City of Burlingame

Meeting Minutes Planning Commission

- b. 1457 El Camino Real, zoned R-3 - Application for Condominium Permit, Design Review and Conditional Use Permit for building height for a new 4-story, 9-unit residential condominium building. (Rabih Balout, applicant and property owner; Troy Kashanipour, architect) (135 noticed) Staff Contact: 'Amelia Kolokihakaufisi

Response to Design Review Study Session #2.

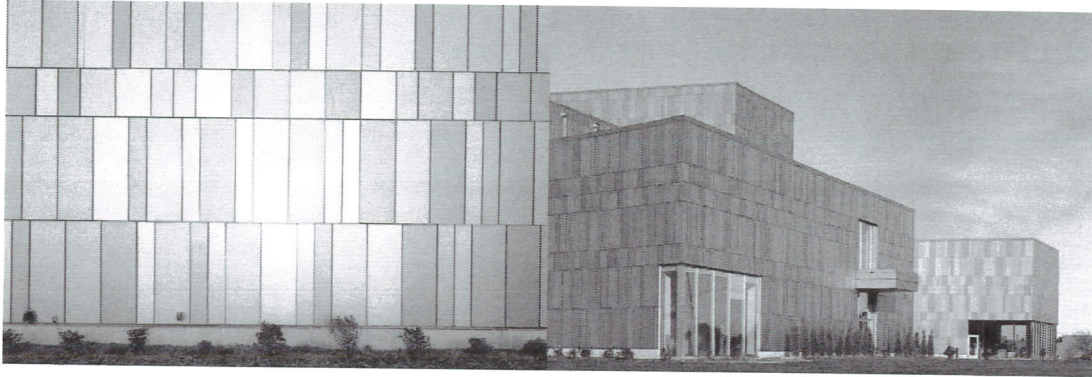
Comment: How do panels close at corners of the building?

Response: The design team appreciates the questions from the Commission. As part of the process of seeking clarity the designers meet with a panel manufacture, *Dri-design*, who provided information on the panel joints, sizes, as well as cost information. What we had previously proposed at the façade was called a double tapered panel – folding both vertically and horizontally. Preliminary pricing for this system was landing in the \$200/per square foot range, and thus, prohibitively expensive. The project designers worked with the *Dri-design* team to identify less expensive alternatives keeping a similar concept at building façades.

Panels at the front façade have been simplified to single-tapered panels. The color of the folded panels will shift subtly based on the view angle to the panel, creating subtle visual interest while a unified paint color creates a calm background for the taller trees planted at the front landscaping area.

The side facades have been revised to reflect a flat panel. To create a similar effect of subtle changes in light we are introducing slight variation in color across the side facades. The paint coating would be a Kynar 2-coat Mica, matt finish with color tending toward the warmer tones.

The panels on the front façade will wrap the corners as corner units. Side façade wall panels will be finished at window openings with a 1 ½" trim piece that slots into an extrusion around the window. The flat panel system is the *Dri-design En-v* system.

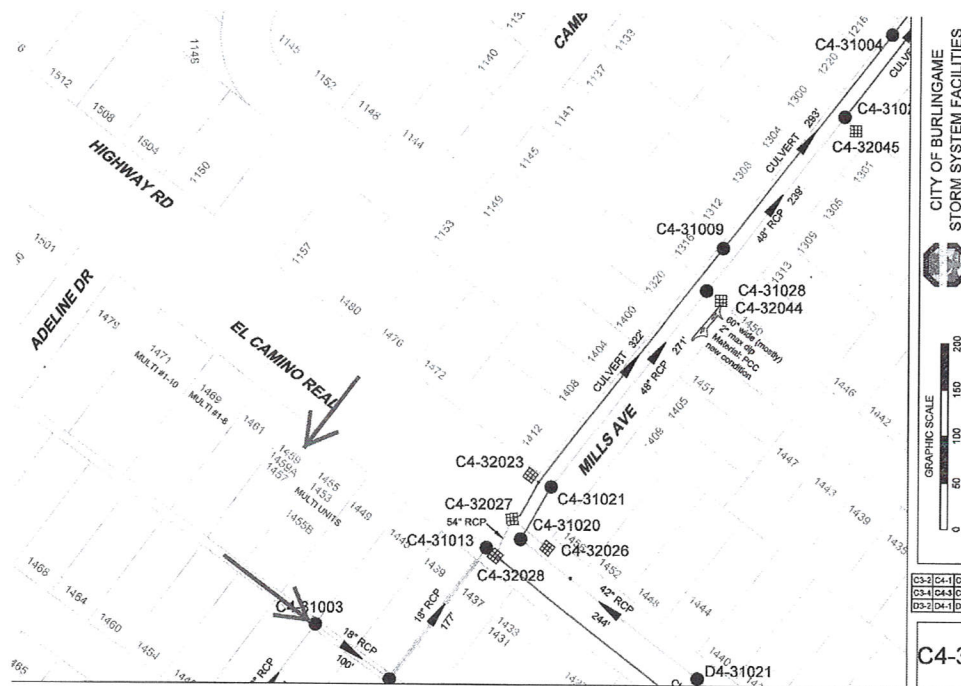
Comment: Concern with Logistics and Constructability of Basement:

Response: The project Engineer and the Geotechnical Engineer have a plan for shoring and sequencing the work to provide support to adjacent properties during construction. Sheet piling will be installed. The basement will be excavated to a depth of 5' below grade. Beyond the 5' depth, the remainder of the basement will be excavated and walls/footings poured in sections. A conceptual drawing is provided at the end of the submittal package. The Engineer will be at the Commission hearing to answer specific questions.

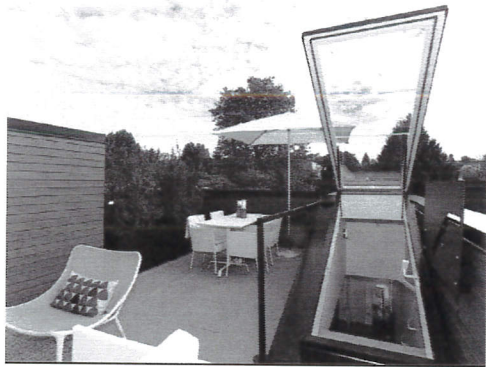
Alternative Parking and Curb Cuts:

The parking condition remains code compliant including resident parking spaces, guest spaces, a delivery space, ADA compliant spaces, and an accessible loading zone.

Car stackers were considered early in the project but rejected because of issues around usability, maintenance, noise, and safety. Stackers were not seen to provide any great advantage over more conventional surface and below grade parking. Car stackers would require a variance from the Planning Code.

Consultation at the Caltrans District 4 office indicated that the 2 curb cuts fit a pattern along El Camino, with some frontages effectively very large curb cuts. Having two curb cuts allow each cut to serve fewer vehicles and potentially reduce congestion and vehicle conflict. The two curb cuts also allows the building to provide the code required number of space. Eliminating a curb cut allows a maximum of 9 parking space, with 3 of those being delivery and service spaces, thus allowing only 3-4 units on the property which is greatly under the allowable density.

Piston hatch

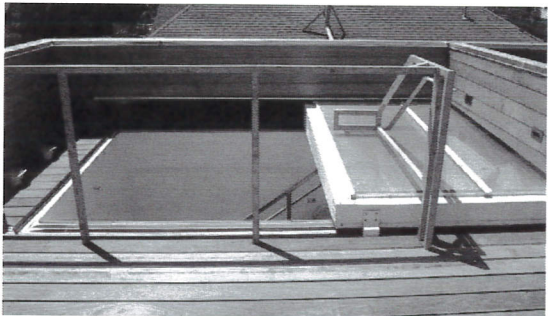
As the size of stair penthouse were of concern to Commissioners options were explored. These options included the use of roof hatches, such as those on pistons, or rolling skylights illustrated below.

The use of a roof hatch is more common in single family home where individual owners are responsible to properly maintain and know the limits of the hatch. Ownership and Architect had

concerns about use of a roof hatch in a rental situation. Tenants will be unfamiliar with the mechanism and that inappropriate use or malfunction could represent a significant safety and liability concern. Therefore roof hatches were not seen as appropriate for this application.
